CITY OF MILWAUKIE

DESIGN AND LANDMARKS COMMITTEE

- 6.1 Summary: Downtown design review process (continued)
Staff People: Brett Kelter, Associate Planner; Elizabeth Decker, JET Planning
- Test case review

Figure A-1: Frontage Occupancy Requirements and Build-To Line

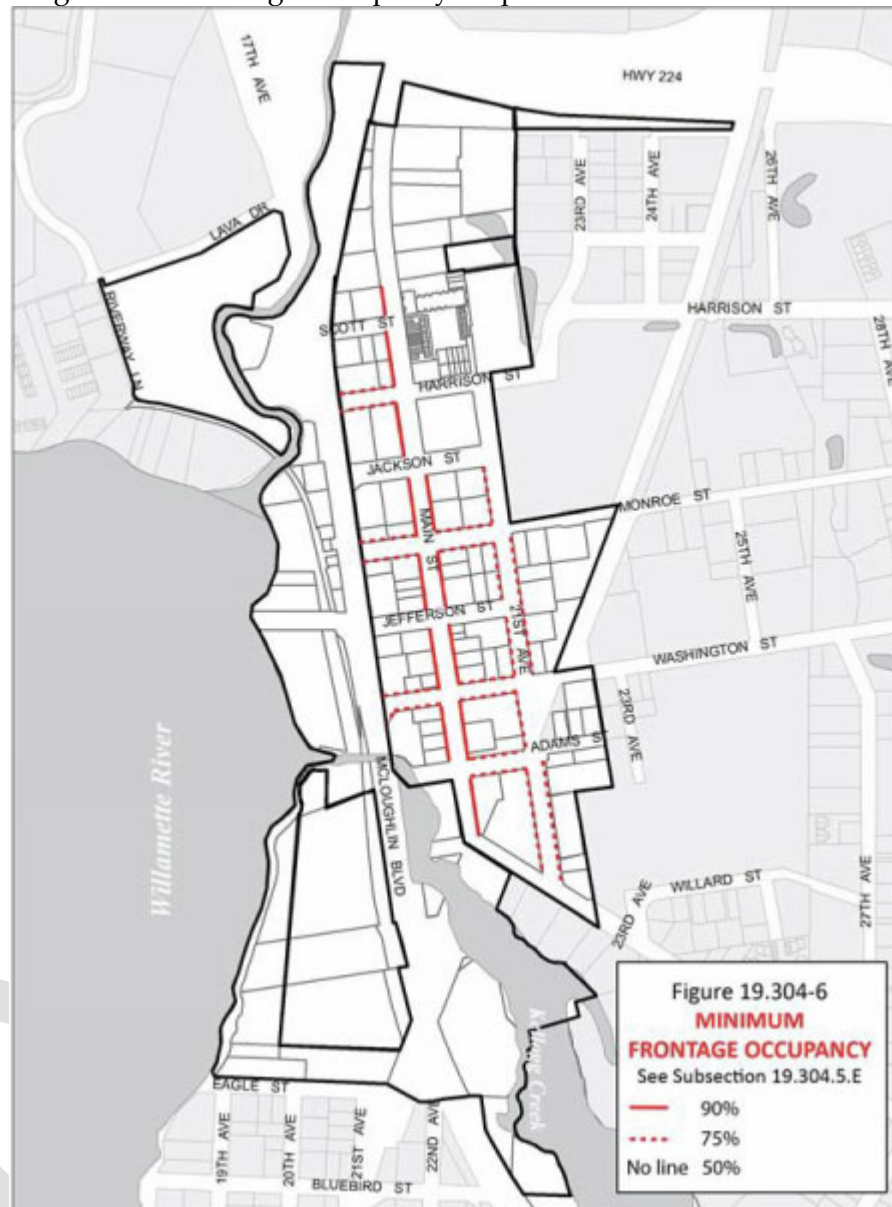
Revise to show:

- Main St = Set at 75% north of Scott St.
- Jackson St = Set at 75% west of Main St.
- Jefferson St = Set at 75% on both sides of Main St.
- Consult with City Hall repurposing committee to identify appropriate percentages for the City Hall block, if any, or leave as is without additional requirements.

Figure: Flexible Ground-Floor Space Standards

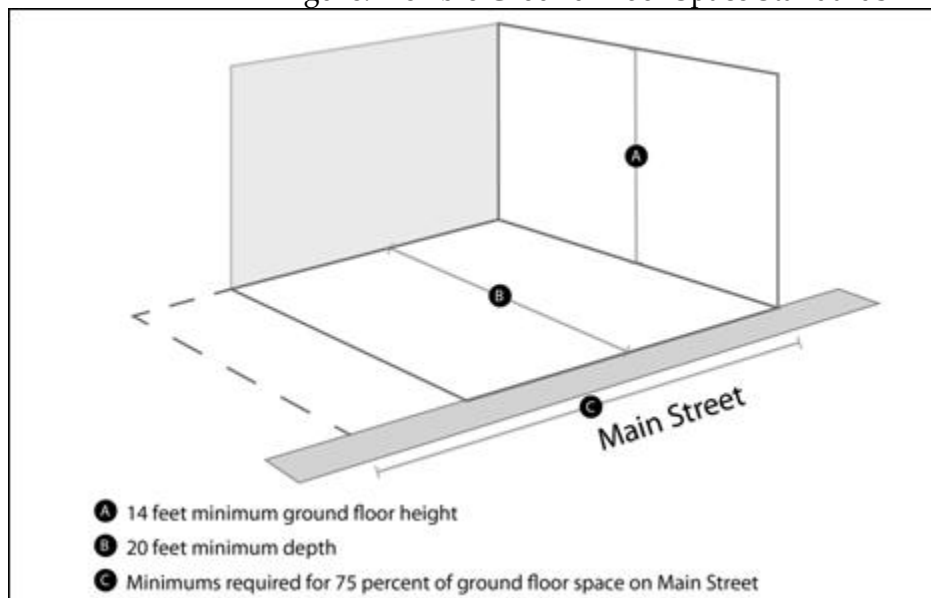
- *Keep graphic illustrating first-floor build-to lines (Figure 19.304.5.D.2.b(1&3))*
- *Keep graphic on flexible ground-floor space standards (Figure 19.304.5.C.2), increase minimum ground floor height to 15 ft.*

Figure: Primary Entrance Standards

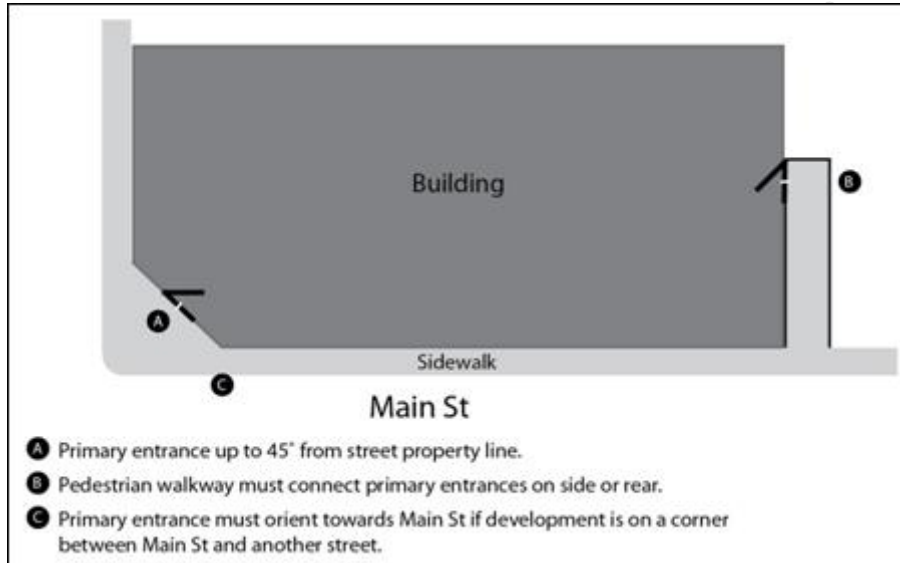
- *Keep graphic on primary entrance standards (19.304.5.F.2). Delete Point C about Main St orientation to allow either corner or Main St orientation.*

Figure: Corner Standards

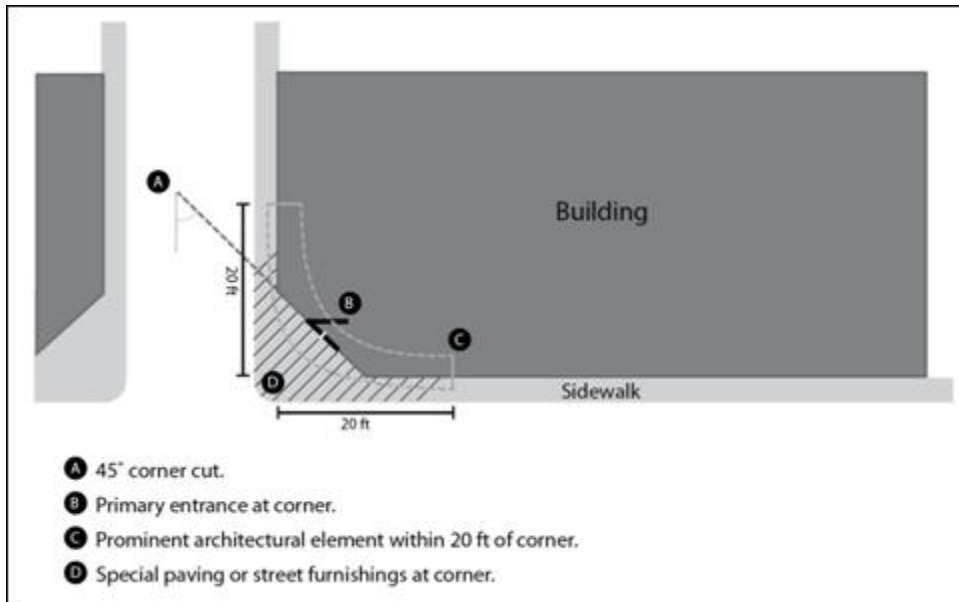
Notes on Figures

- *Make the image larger and clearer—zoom in on the corner of the graphic to show more detail.*
- *For purposes of the illustration, the door should swing out.*
